DART AEROSPACE LTD	Work Order:	107456
Description: Crosstube Assembly (206L High Fwd)	Part Number:	D206-667-143
Inspection Dwg: D206-667-143 Rev: C		Page 1 of 2

DESIGN	97	DART AEROSPACE LTD	
DRAWN	RF	HAWKESBURY, ONTARIO, CANADA	
CHECKED	97	DRAWING NO.	REV. C
MFG. APPR.	97	D206-667-143	SHEET 2 OF 4
APPROVED	97	TITLE	SCALE
DE APPR.	97	CROSSTUBE ASS'Y (206L HIGH FWD)	NTS
DATE	08.11.06	<small>COPYRIGHT © 2000 BY DART AEROSPACE LTD THIS DOCUMENT IS PRIVATE AND CONFIDENTIAL, AND IS SUPPLIED ON THE EXPRESS CONDITION THAT IT IS NOT TO BE USED FOR ANY PURPOSE OR COPIED OR COMMUNICATED TO ANY OTHER PERSON WITHOUT WRITTEN PERMISSION FROM DART AEROSPACE LTD.</small>

DRAWING NO. D206-667-143	TITLE CROSSTUBE ASS'Y (206L HIGH FWD)	REV. C	DART AEROSPACE LTD ENGINEERING ORDER		D.E.O. NO. D206-667-143-C-1	SHEET NO. SHEET 1 OF 1	SCALE NTS
DRAWN 97	CHECKED ASS	MFG. APPR. 11/07/21	APPROVED MD		DE APPR. 11/07/21		
DATE 11.07.15	DATE 11.07.20	DATE 11.07.21	DATE 11/07/21		DATE 11.07.21

DRAWING NO. D206-667-143	TITLE CROSSTUBE ASS'Y (206L HIGH FWD)	REV. C	DART AEROSPACE LTD ENGINEERING ORDER		D.E.O. NO. D206-667-143-C-2	SHEET NO. SHEET 1 OF 1	SCALE NTS
DRAWN AJS	CHECKED		MFG. APPR. <i>E</i>	APPROVED <i>

DETAIL P
 BONDING STRAP INSTALLATION 2 PL

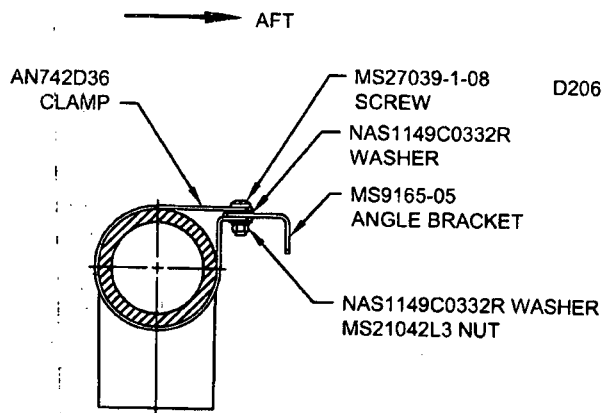
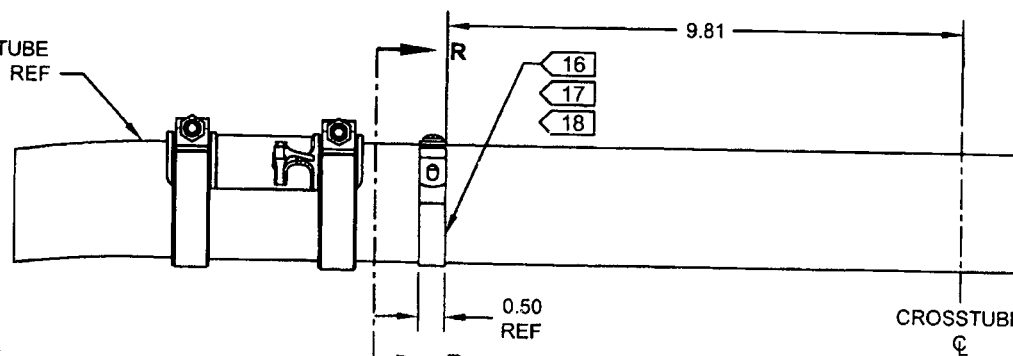
ADD ELECTRICAL GROUNDING STRAP

ITEM	QTY -143	PART NUMBER	DESCRIPTION
1	X	D206-667-143	CROSSTUBE ASSEMBLY (206L HIGH FWD)
10	2	AN742D36	CLAMP
11	2	MS9165-05	ANGLE BRACKET
12	2	MS21042L3	NUT (OR MS21042-3)
13	2	MS27039-1-08	SCREW
14	4	NAS1149C0332R	WASHER (OR AN960C10L)

- 16) MASK AREA UNDER CLAMP PRIOR TO PAINTING
- 17) SEAL EDGES WHERE AN742D36 CLAMP MEETS WITH THE CROSSTUBE USING SIKAFLEX-241/-291 OR MIL-S-8802 CLASS B2 OR PROSEAL 890 SEALANT
- 18) PERFORM RESISTANCE CHECK TO ENSURE MAX RESISTANCE IS 10 MILLIOHMS
